**Economic and Social Council**Distr.: General  
27 November 2014

**World Forum for Harmonization of Vehicle Regulations****Working Party on Passive Safety****Fifty-sixth session**

**Regulation No. 127 (Pedestrian safety)****Proposal for Supplement 1 to the 01 series of amendments to Regulation No. 127 (Pedestrian safety)****Submitted by the expert from the European Commission as Chair of the Task Force on Bumper Test Area within the Informal Working Group on global technical regulation No. 9 Phase 2\***

"Figure 5A

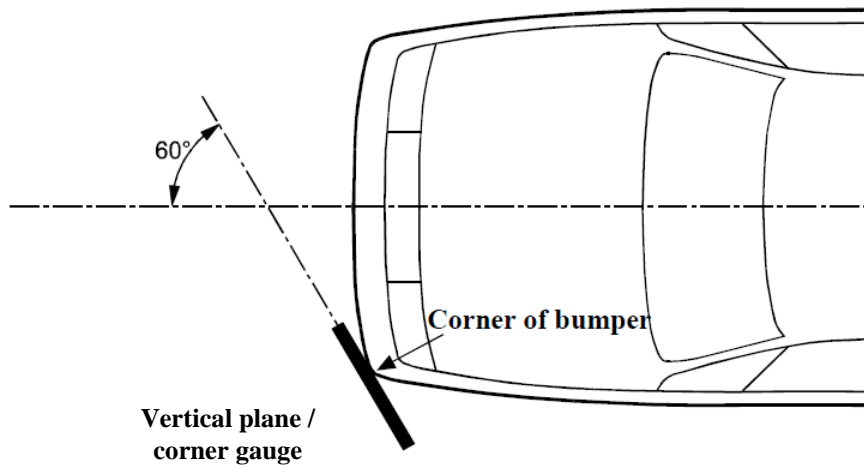
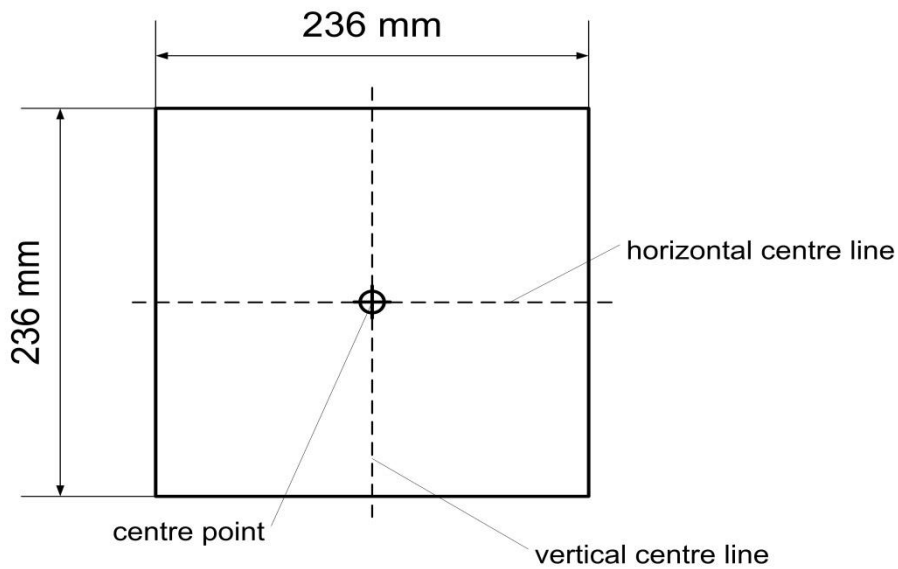
Figure 5, amend to read:

**Corner of bumper example (see paragraph 2.17., note that the corner gauge is to be moved in vertical and horizontal directions to enable contact with the outer contour and front fascia of the vehicle)**
